#37/3-94CC Cont'd 506 Tulip Avenue
Takoma Park Historic District

*Rauitz
506 Tulip Avenue
Takoma Park District District
MPC 8/11/94*

506 TULIP AVE. - GARAGE

Photo of carpet taken from my deck.
Note: deck rail was included so that size
could be seen.

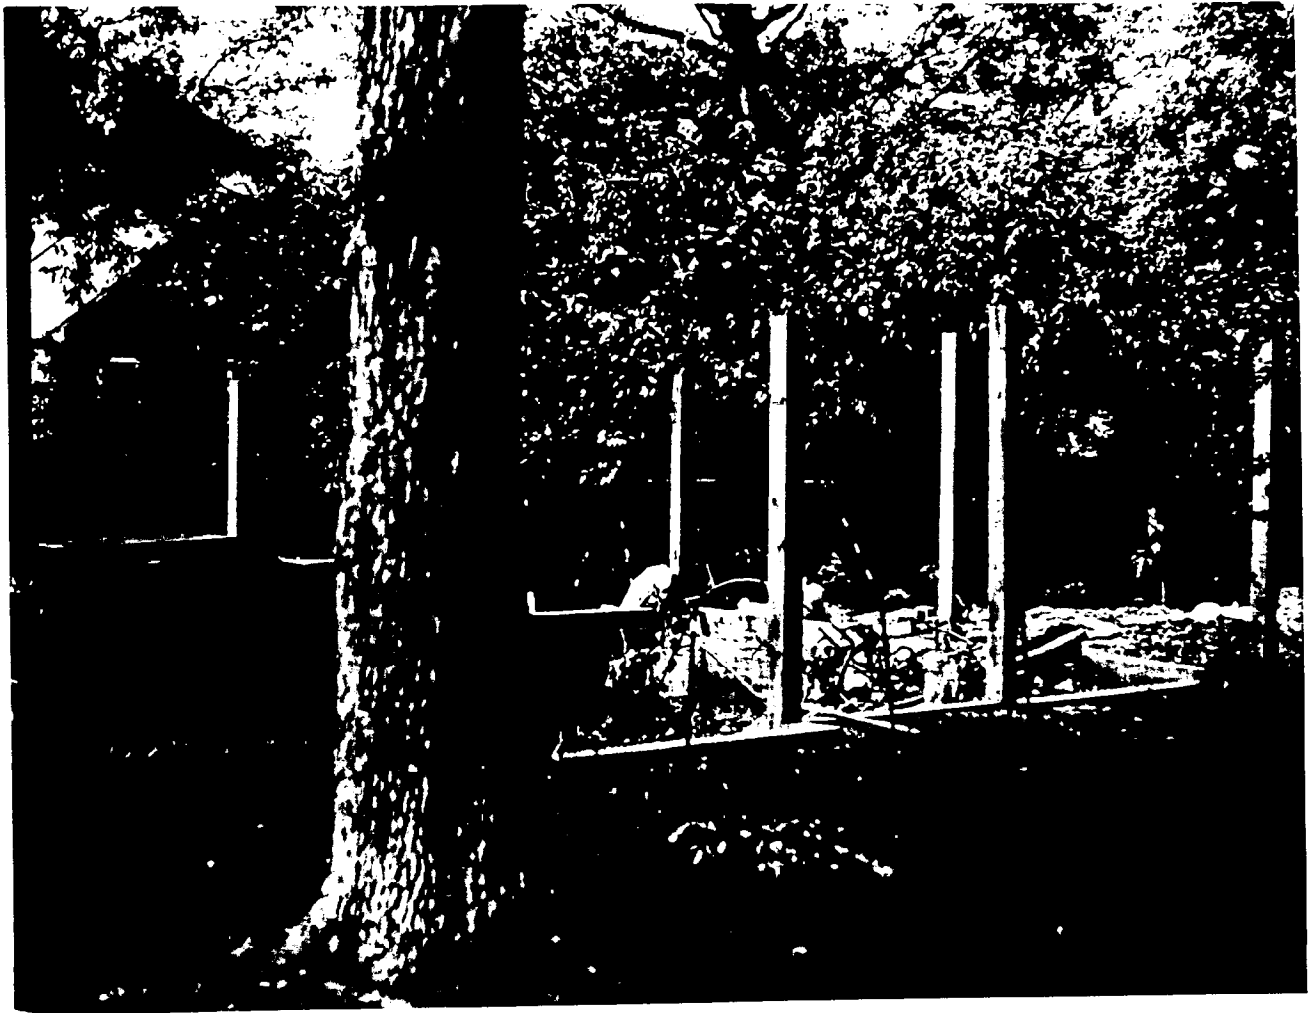
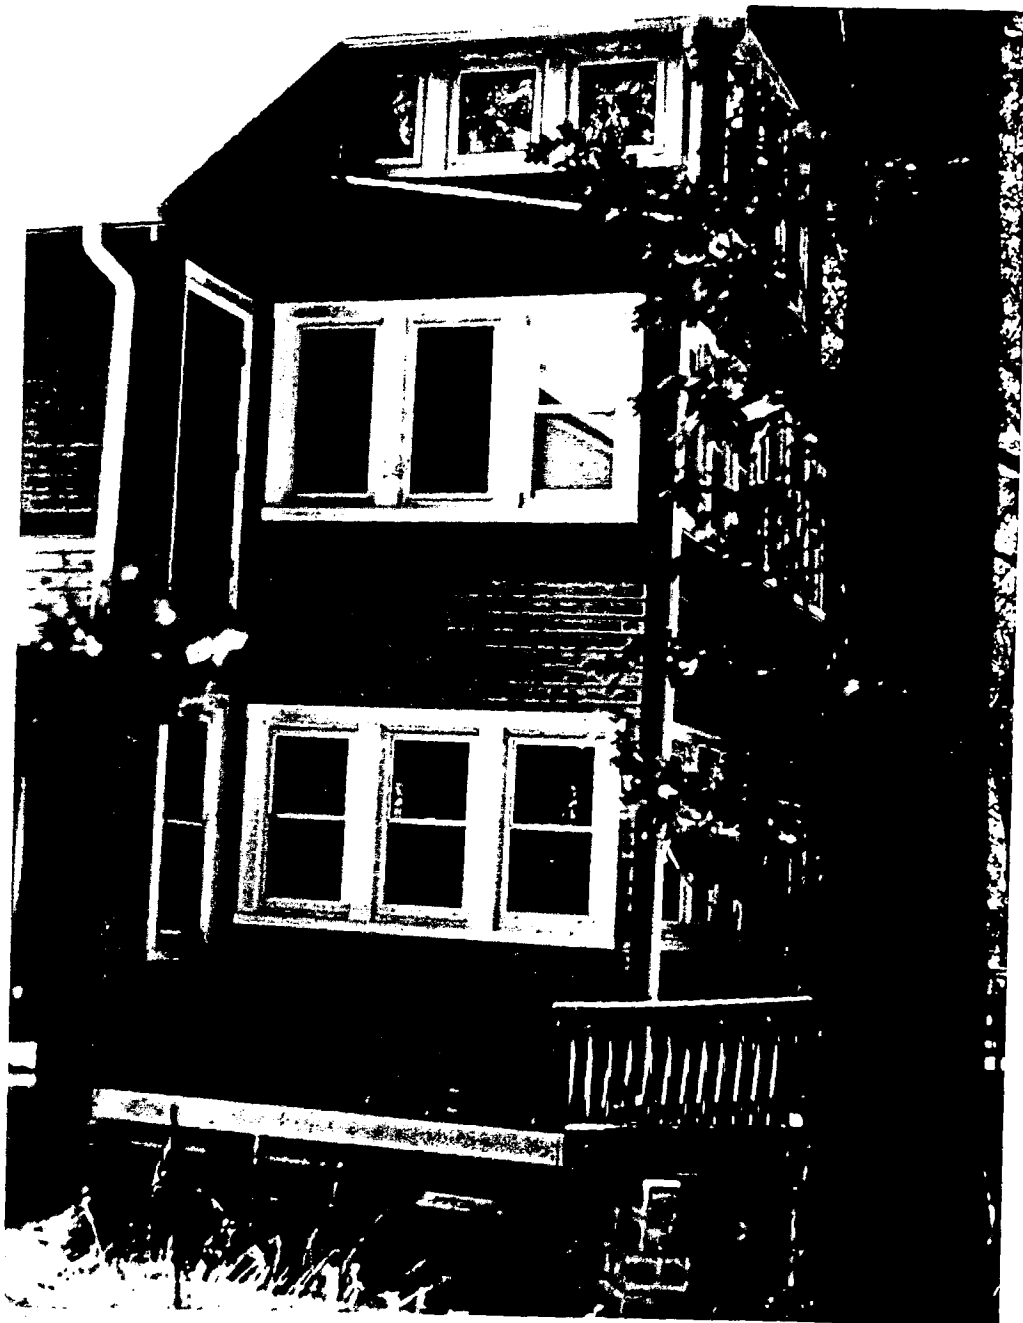
- The enhanced photo makes this deck look almost square. The actual dimensions of the corner of the house are more like 5'x10'. The lot plan states 6'x10'. I have enclosed a picture which provides a different view of the dimensions of the proposed deck.

-There is insufficient detail to ascertain the structural stability and integrity of this deck. I estimate that this proposed deck may be approximately 20' off the ground. There may be a need for cross bracing which would significantly change the design and appearance of the structure.

506 TULIP AVENUE - RAVITZ 2ND STORY DECK DETAIL

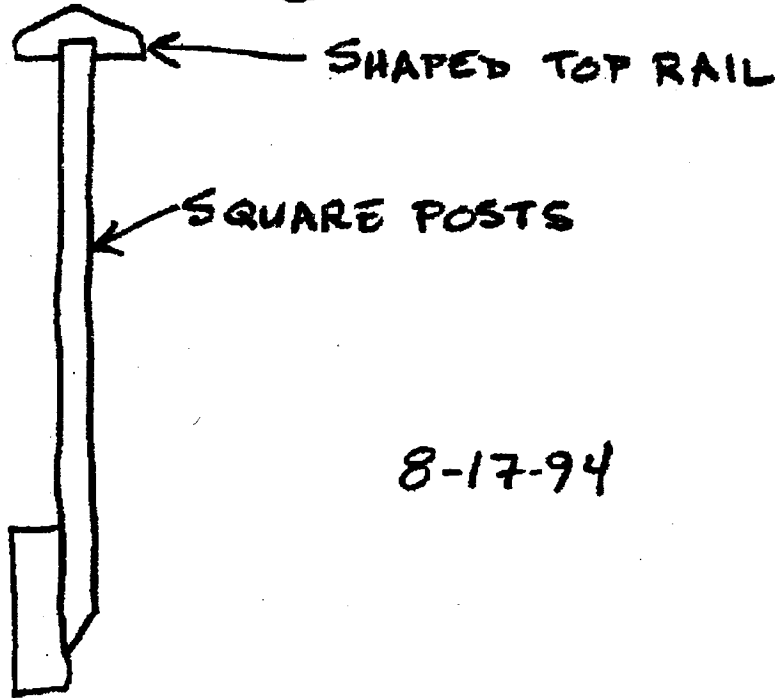
I am faxing you the 2nd story porch detail. Please call me to let me know if this is satisfactory. The rail and posts are designed to match the large existing deck. Your suggestions are welcome. I will attempt to make the changes immediately, so that you can have an acceptable design this afternoon, before tonight's hearing.
